PRODUCT/PROCESS CHANGE NOTIFICATION

PCN MPG/SR/2003004

MATERIAL CHANGE FOR ALL ST ZEROPOWER AND TIMEKEEPER NVRAMS IN DIP24 AND DIP28 CAPHAT PACKAGES

PCN MPG/SR/2003005

Figure 2. Assembly Site Trace Code (Row 5)

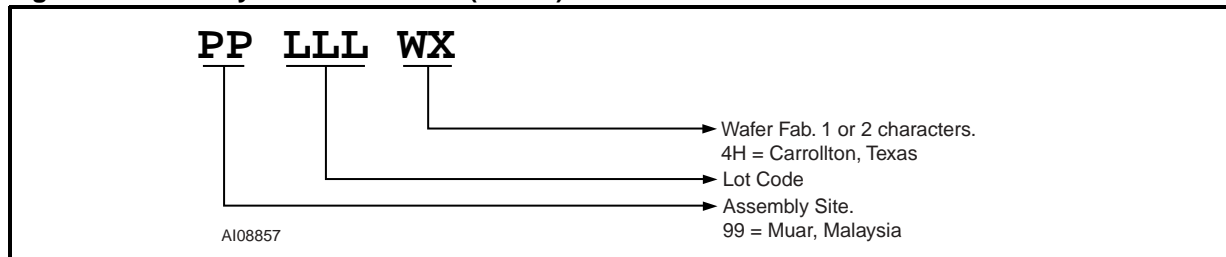
The Lead-free parts can be identified in three ways: The letter E (as in ECOPACK®) will appear in the brand. Furthermore, the trace code can be used to determine the time and place of manufacture, and hence the material content. Finally, the Lead-free parts will be labeled in a new format as shown in Figure 1, Figure 2, and Figure 3.

Note: 1. The last two rows comprise the trace code, formatted as in Figure 2 and Figure 3, page 2.
 2. The rotated text on the right ("BBBB") is the battery trace code.

Figure 3. Country of Origin Trace Code (Row 6)

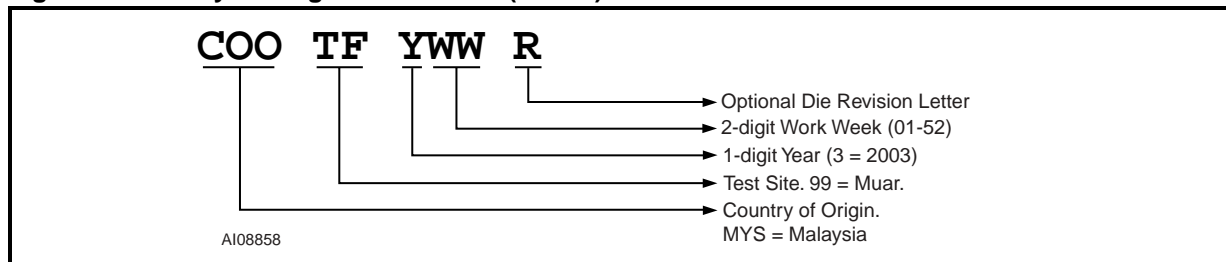
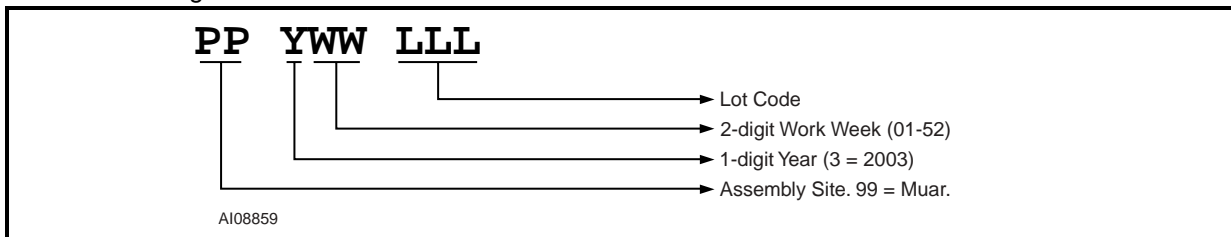
The full trace code per ST's new standard will be shown on the end of the inner bulk box (i.e. box inside shipping carton) as shown in Figure 3.

Figure 2. Assembly Site Trace Code (Row 3)

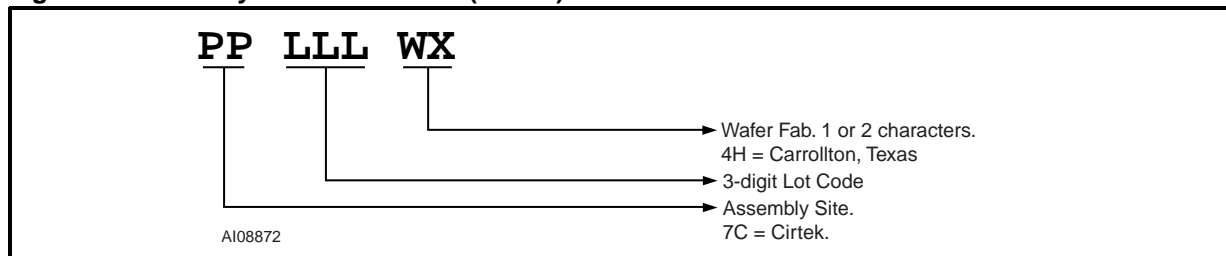
Lead-free parts will be marked with an "E" (representing ECOPACK®) branded onto the IC packages. The brand includes the trace code, and has the format shown in Figure 1, Figure 2, and Figure 3.

**Figure 5. Inner Bulk Box Labeling**

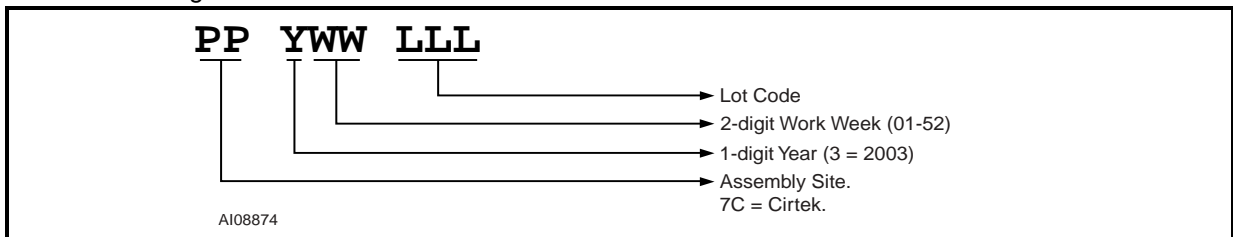
The trace code will also be shown on the end of the inner bulk box (i.e. box inside shipping carton) as shown in Figure 5.

The trace code is also contained on the label on the inner bulk box (i.e. box inside shipping carton), and has the following format:
